Job Number: 17_144

SUBJECT: Ohinewai Structure Plan: Proposed District Plan Submission: Ambury Properties Limited Update

Attachment A: ITA Appendix B proposed upgrade cross-sections drawings

TYPICAL CROSS SECTION THROUGH TAHUNA ROAD SECTION A-A ("RURAL SECTION")

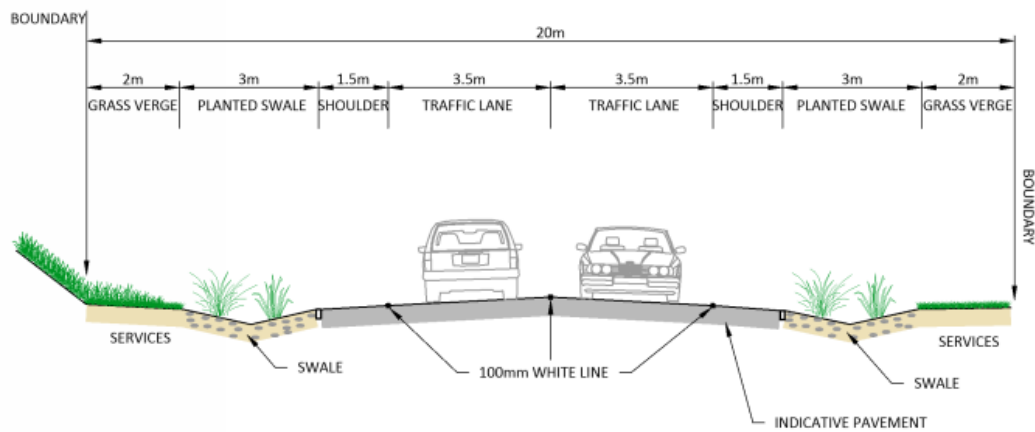
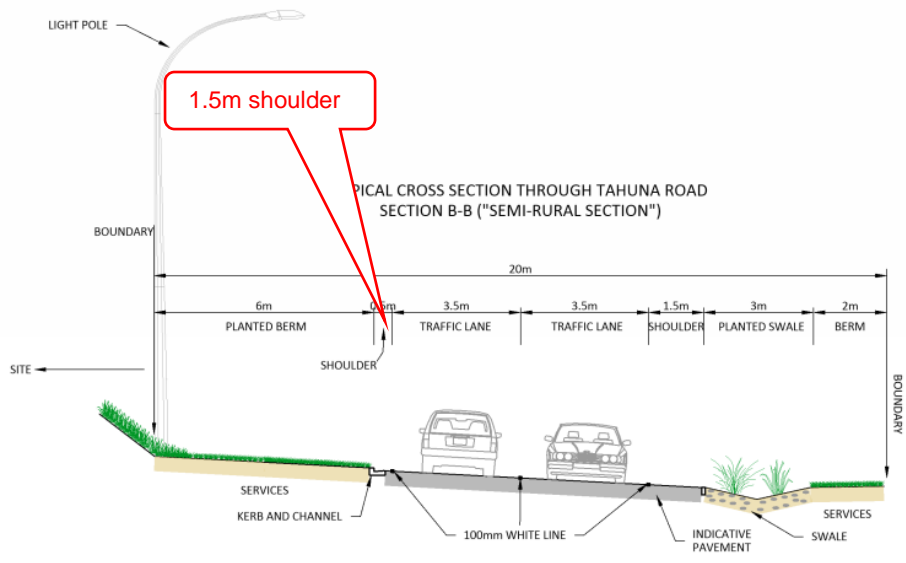
Tahuna Road ("rural section" A-A BBO drawing 145860-08-0206 Rev B) east of the Access 2 (Tahuna roundabout) to the eastern extent of the OSP (no change needed).

Lumsden Road ("semi-rural" section, D-D, BBO drawing 14580-08-0209 Rev B) between Tahuna Road and Access 4 should include 1.5m shoulder on the eastern side to facilitate cyclists on-road with the shared path along the eastern berm.

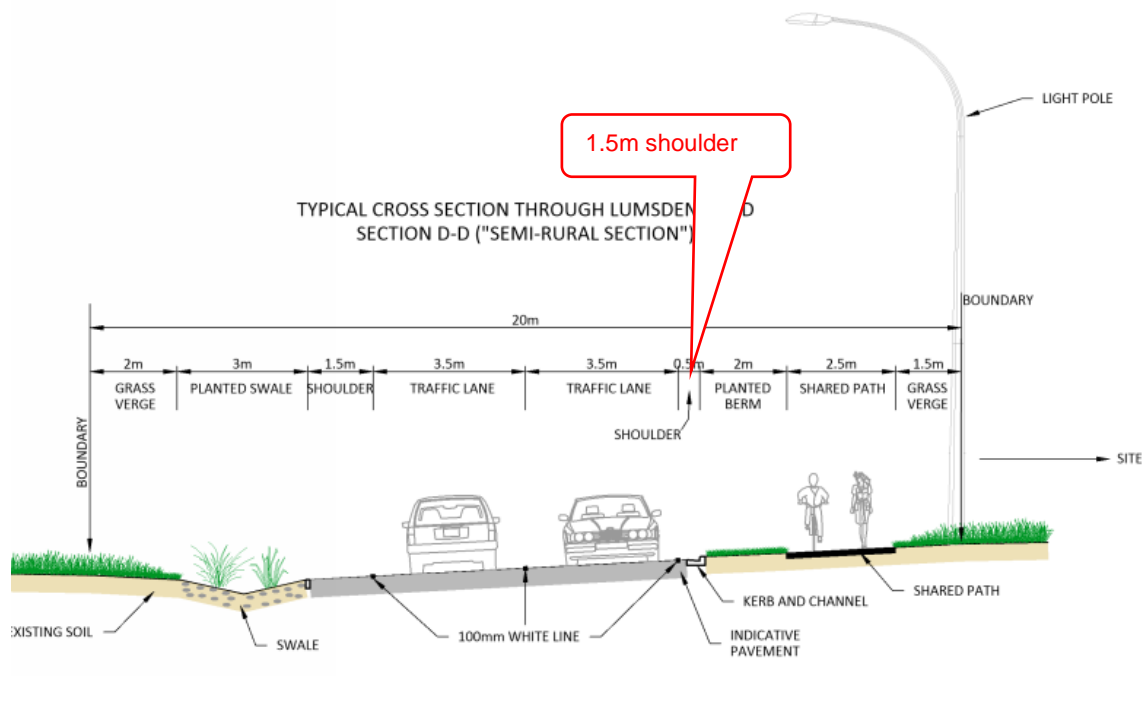
There is an existing drain on the western side that may need to be piped and should be considered at detailed design.

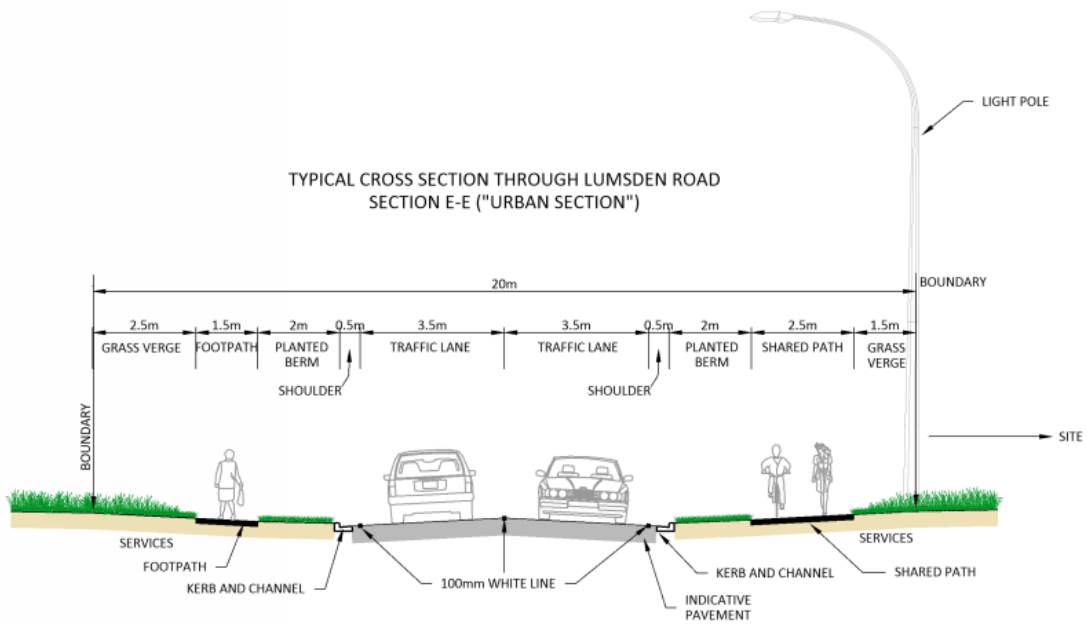
Lumsden Road ("urban" section, E-E, BBO drawing 145860-08-0210 Rev B) between Access 4 and the Factory Access A (where there are existing residential properties on the western side) includes footpath on the western side and the shared path along the eastern side should connect to the Factory Access. (No changes needed).
